ATTACHMENT 7
PLAN REVIEW COMMENTS FOR COFA-02-26-020148

Town of Bluffton
Department of Growth Management
20 Bridge Street P.O. Box 386 Bluffton, South Carolina 29910
Telephone 843-706-4522
TOWNE CENTRE AT NEW RIVERSIDE

Plan Type:	Highway Corridor Overlay District	Apply Date:	02/26/2026
Plan Status:	Active	Plan Address:	2800 May River Xing Crossing BLUFFTON, SC 29910
Case Manager:	Angie Castrillon	Plan PIN #:	R610 036 000 3212 0000
Plan Description:	A request by Josie Abrams of Josie S. Abrams Architecture, on behalf of property owner Beaufort Memorial Hospital for review of a Certificate of Appropriateness - HCOD application. The project consists of the 5,000 S single story medical office building with associated infrastructure. The property is zoned Jones Estate Planned Unit Development (PUD) and consists of approximately 1.38 acres identified by tax map number R61 036 000 3212 0000 located within the May River Crossing Master Plan. STATUS: This item will be heard at the April 1, 2026 Development Review Committee Meeting.

BEAUFORT MEMORIAL MAY RIVER PRIMARY CARE

A210

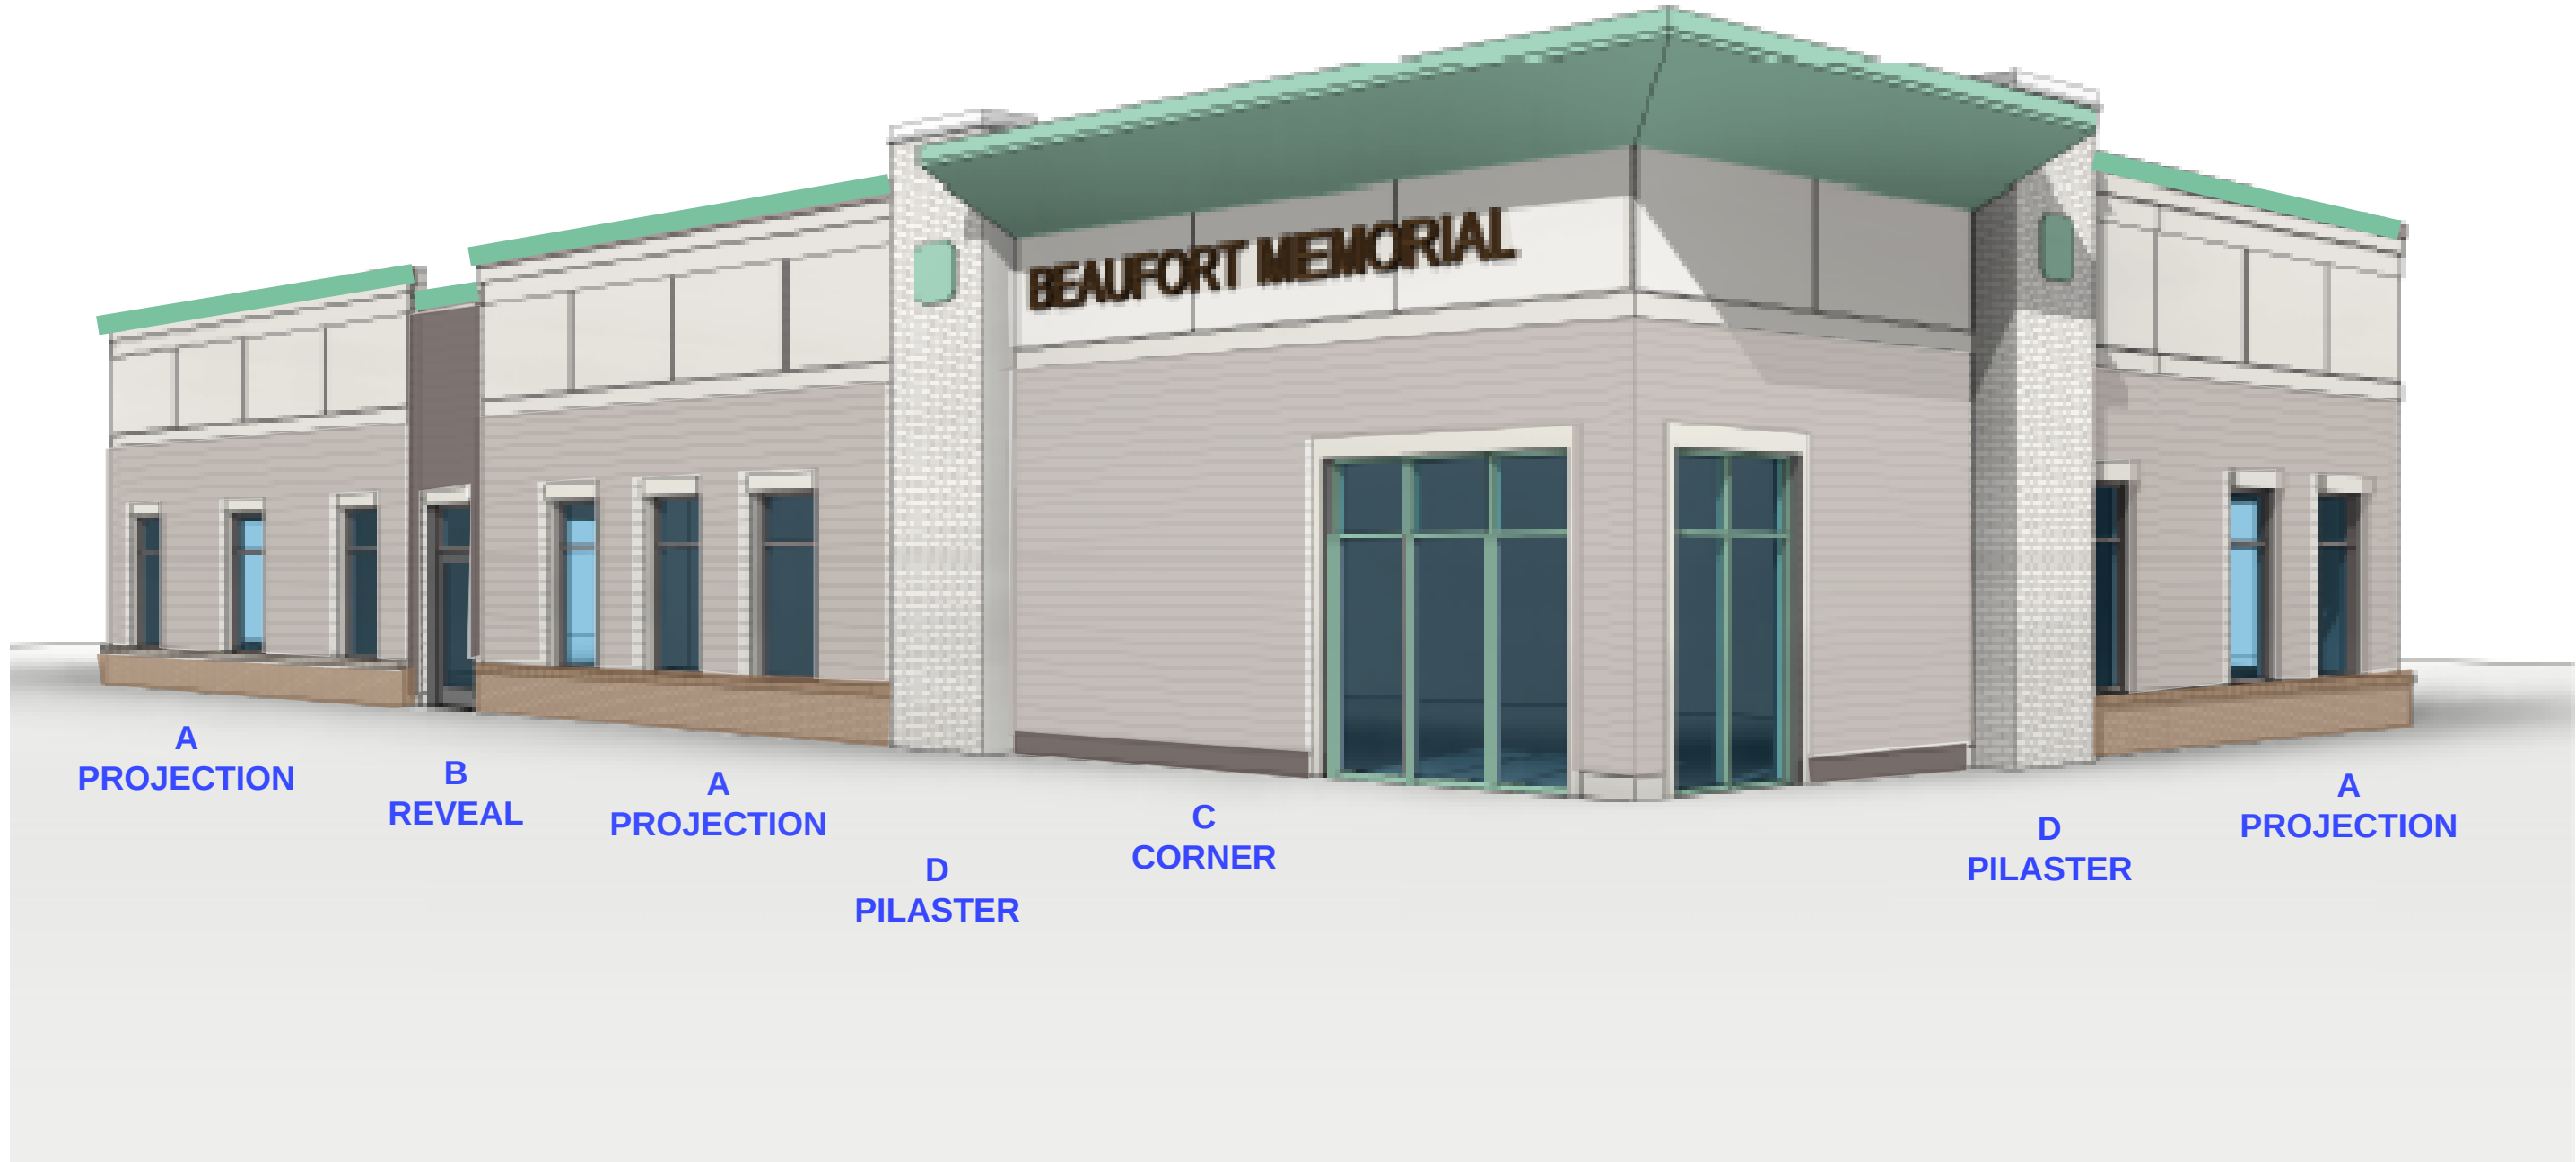
1. The use of "Aged Copper" for the cornice at the two corners and the storefront windows is not considered compatible with the Lowcountry or coastal vernacular palette (ZDSO 90/3 Section 5.15.9.C.1 and 5.15.9.D.5) The use of the corporate color as an accent may be considered on a case-by-case basis.
